UNITED STATES PATENT AND TRADEMARK OFFICE

APPLICATION NO.	FILING DATE	FIRST NAMED INVENTOR	ATTORNEY DOCKET NO.	CONFIRMATION NO.
10/024,507	12/21/2001	Donald E. Bobbitt	42072	2198

Office Action Summary

Part II DETAILED ACTION

(EXHIBIT A)

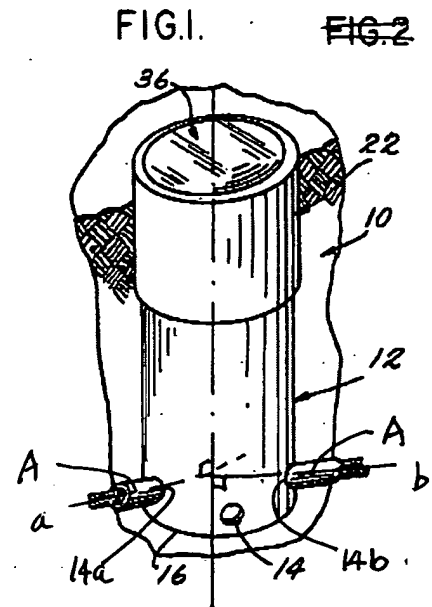
White shows and discloses a light fixture foundation comprising: a hollow shaft (12) having a tubular wall extending inherently along a central longitudinal axis, a plurality of cableway openings (14) extending through the tubular wall along axes substantially perpendicular to the central longitudinal axis, wherein the cableway openings (14) being located substantially in a same lever but laterally spaced from each other, at least two cableway openings (14a , 14b) extending through the tubular wall along a first axis (a-a) and a second axis (b-b) which are considered to disposed on diametrically opposing sides of the hollow shaft and are substantial parallel to each other which are non-coaxial as claimed (see Fig. 1 shown bellow), at least two cableways (A) supporting electrical wiring (18, 40) and being received in the respective cableway openings, said cableways being substantially at a same vertical lever such that the cableways are positioned co-planar with respect to each other (see Fig. 2), and a support member (22) for supporting a lighting assembly (30) coupled to the shaft, said support member having a passageway (26) in communication with the hollow shaft to receive the cableways such that the cableways can be extended through the passageway without interfering each another. Notice, the cableways are inherently “rigid” than the wires (18) for guiding the wires (18) thought the opens

is not treated on merits. In fact, the cableways (A) of Whrite's device are considered to be substantially "rigid" than the wires (18) for guiding the wires through the wall and the passageway. Second, as mentioned by applicant, White shows the light fixture foundation having holes (14) disposed around the hollow shaft (12) at different positions aground the surface of the hollow shaft. Due to the diametrical shape, the adjacent holes (14) of White are considered disposed on diametrically opposing sides and laterally spaced from one another since the hollow shaft is circular in shape, and the adjacent holes (14) which is disposed at 0° and 90° , or 90° and 180° are considered to have axes being non-coaxial (see EXHIBIT A shown above) but disposed co-planar (the axes are perpendicular to each other in same level. See Figs. 1 and 4) as claimed. In addition, applicant only recites "the cableway opening extending through the tubular wall along a first/second axis", technically, an opening is not necessary to be a "circular" but would any other shapes, so the axis would be located anywhere within the opening, and directs to any directions (See illustration show in EXHIBIT A). Since applicant does not specifically define where are the first and second axes located along the cableway openings and how the axes disposes as relative to the openings, the opposing openings (14a, 14b) of White's device are considered to have first and second axes (a, b) through the wall and parallel and non-coaxial to each other as broadly read on the claims. And, the cableway (A) inherently has a centerlines disposed along the axes as claimed. Further, White teaches the openings being used for separately positioning the cableways in different positions which solves the same problem of preventing the cableway interfering each other as claimed invention. So White's device is considered to broadly read on the claimed invention.

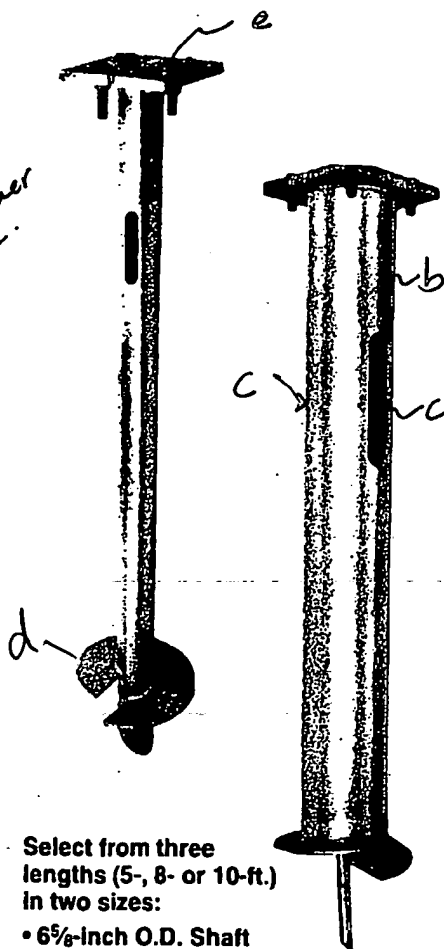
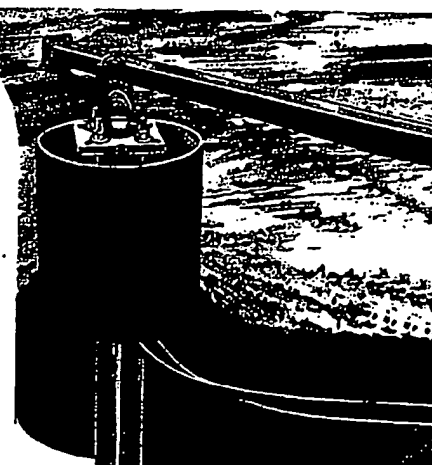
Hubbell Power Systems, Inc. (see attachment) teaches installing on site a lighting fixture foundation comprising a method of excavating a trench (a) having a depth and a width sufficiently receiving the lighting fixture foundation, the lighting fixture foundation comprising an elongated hollow shaft (b) having cableway openings (c) being precut to extend through diametrically opposite surfaces of the tubular wall of the shaft (see the previous page of the attachment), wherein the cableway openings are aligned in a same lever, an anchor (d) at the lower end of the hollow shaft for driving and supporting the hollow shaft through the bottom the trench into the ground, a support member being a base plate (e) fixed to an axial upper end of

the shaft, the base plate having notches (f) to receive bolts (g) for releasably supporting a lighting assembly thereon, the support member having a passageway (h) in communication with the hollow shaft such that cableways (i) are extended through the cableway openings (c) in opposite directions and through the passageway of the support member to the lighting assembly.
